Title: **STAGE 1 ROAD SAFETY AUDIT**

**Primary Care Centre & Nursing Home, Moygaddy, Co. Meath.**

Report reference: **1388R02**

#### 3.1 Problem

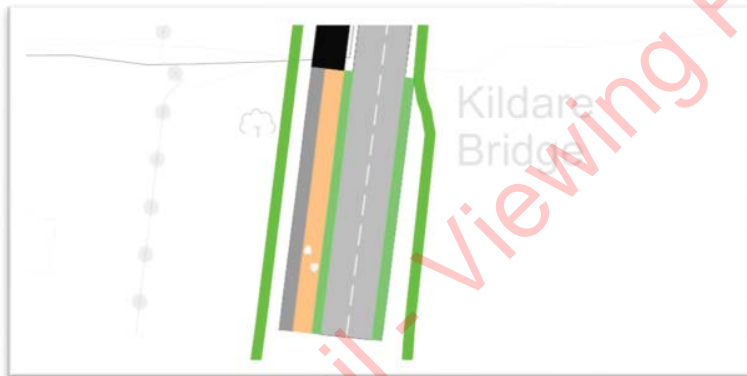
General Comment tie-in points

Details have not been provided of how the cycle track and footpaths will tie in at the scheme extents. Cyclists and pedestrians will have to cross the carriageway to access the facilities. Without suitable transitions from off road to on road and suitable crossing facilities there is a risk that pedestrians and cyclists will be struck by passing traffic.

It is recommended that suitable transitions and crossing facilities be provided. Where this scheme ties in with the other planned scheme to the north a transitional arrangement should be provided should construction of that scheme not proceed.

3.1	Y	Y	The proposed cycle lane across Kildare Bridge will be updated to tie in the existing carriageway R157 and at south cyclist will join carriageway

Drawing S665- OCSC-1B-MH-DR-C-0111 S2 P01 Sheet 2 of 3, cycle track across side road.

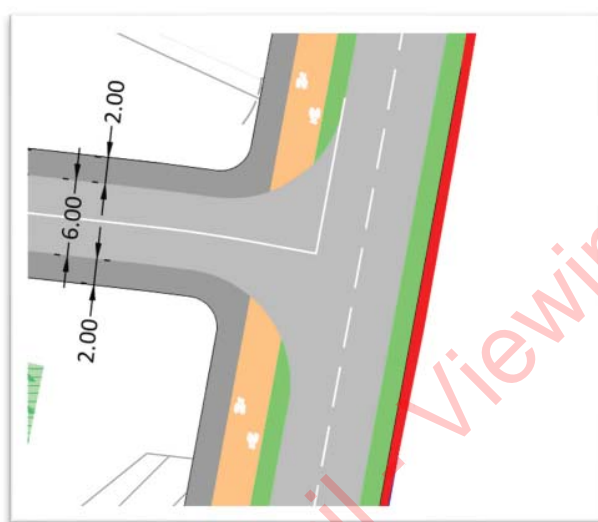
The proposed two way cycle track crosses the mouth of the proposed side road. There is a risk that drivers exiting the side road may not expect two way cyclists as they approach the stop line.

It is recommended that a 'bend out crossing' be provided.

3.2	Y	N	It is proposed to provide a shared space and tactile for crossing before the cyclist and pedestrian approach the junction. A raised crossing will be provided to indicate priority for pedestrians and cyclists.	Yes

Drawing S665- OCSC-1B-MH-DR-C-0111 S2 P01 Sheet 2 of 3, Side road cross section.

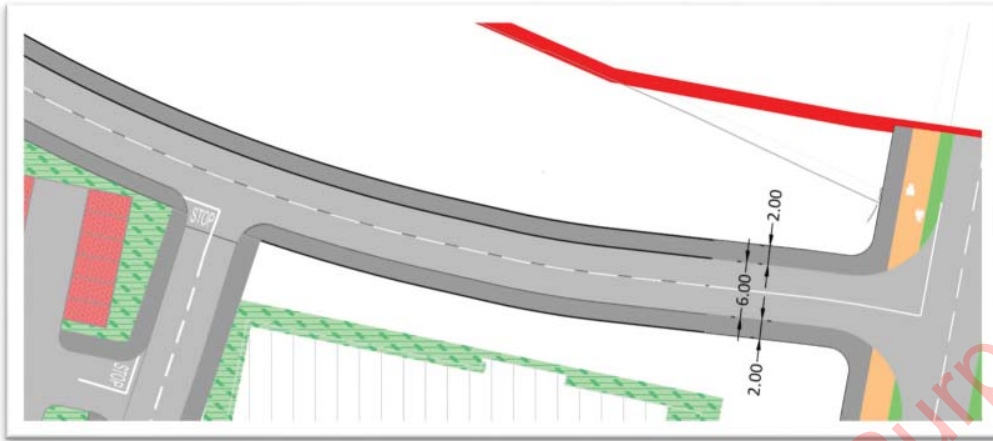
There are no dedicated cycle facilities along the proposed side road. The side road will be a busy area with vehicular traffic when fully developed and this will increase the risk for cyclists.

It is recommended cycle tracks be provided on both sides of the side road.

3.3	Y	N	It is not anticipated to have high volume of pedestrian and cyclist traffic. 2m wide shared use will facilitate pedestrian and cyclist movement	Yes

Drawing S665- OCSC-1B-MH-DR-C-0115 S2 P01 Visibility Splay at side road junction with R157.

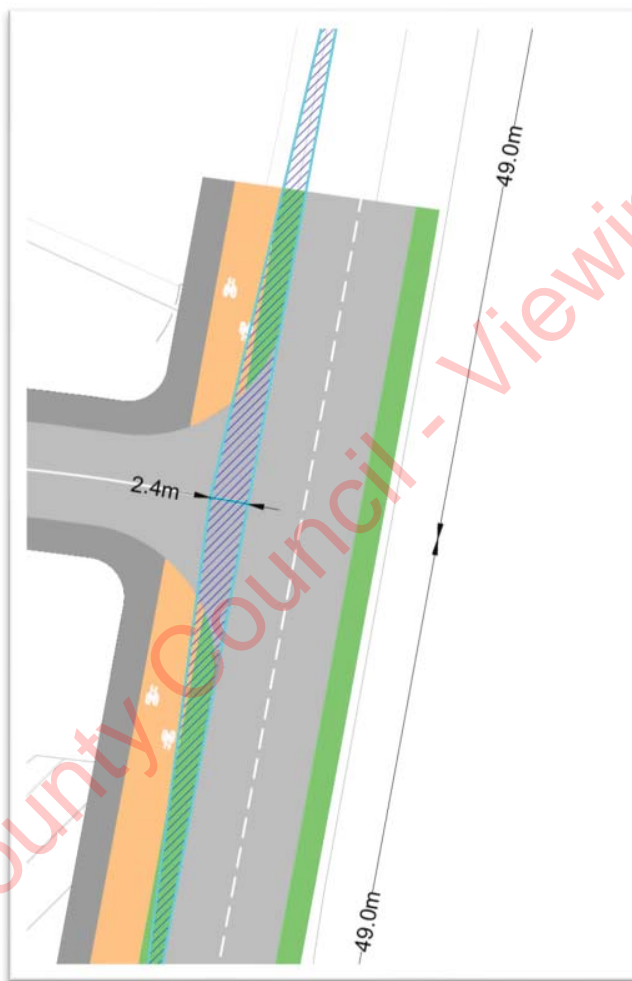
The visibility splay is shown for a 50km/hr urban design speed. The speed limit on the R157 is currently 80km/hr. There may be insufficient visibility to oncoming vehicles leading to side-impact or rear-end collisions.

It is recommended that visibility splays to the posted speed/design speed be provided.

3.6	N	N	The visibility splay is achieved for 50kmph. The new speed limit will be 50kmph once the new distributor road and development is completed.	Yes

Drawing S665- OCSC-1B-MH-DR-C-0112 S2 P01 Sheet 3 of 3, Carton Estate boundary wall.

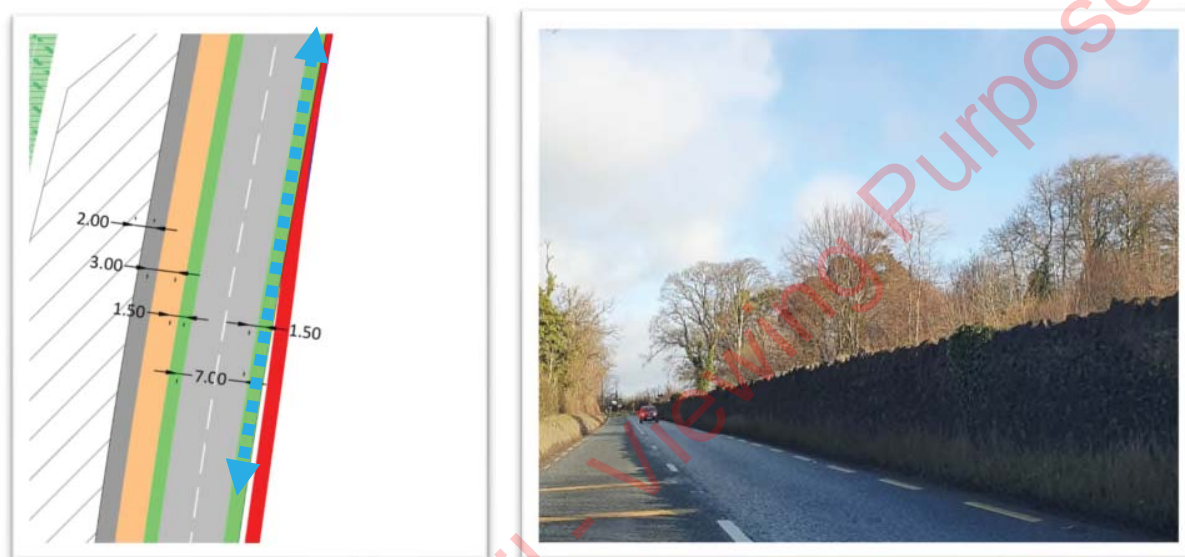
It is proposed to provide a 1.5m verge between the R157 and the Carton Estate boundary wall. The wall may be hazardous if struck by an errant vehicle.

It is recommended that a suitable Clear Zone be provided between the boundary wall and the R157 carriageway.

3.7	N	N	The proposed 1.5 m verge separation is an improvement to the existing condition, and the section of road is straight and the speed limit on the road will be reduced	Yes

once the new distributor road is completed.	
--	--	--	---	--
